RE: **Recall Campaign Launch Notification**

Replace Rear Door Latches

MY19-21 463(G-Class)

Campaign No. 2021060014, July 2021

Figure 2

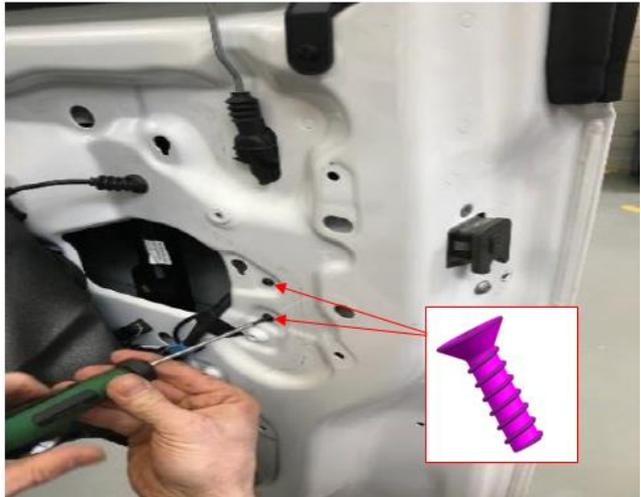
4. Complete unit consisting of door lock, actuator motor of central locking system with release cable, and door locking knob prior to installation and insert into door to assemble.

i The mounting screws on **CL actuators (Figure 3) MUST be replaced** and are included with the parts kit.
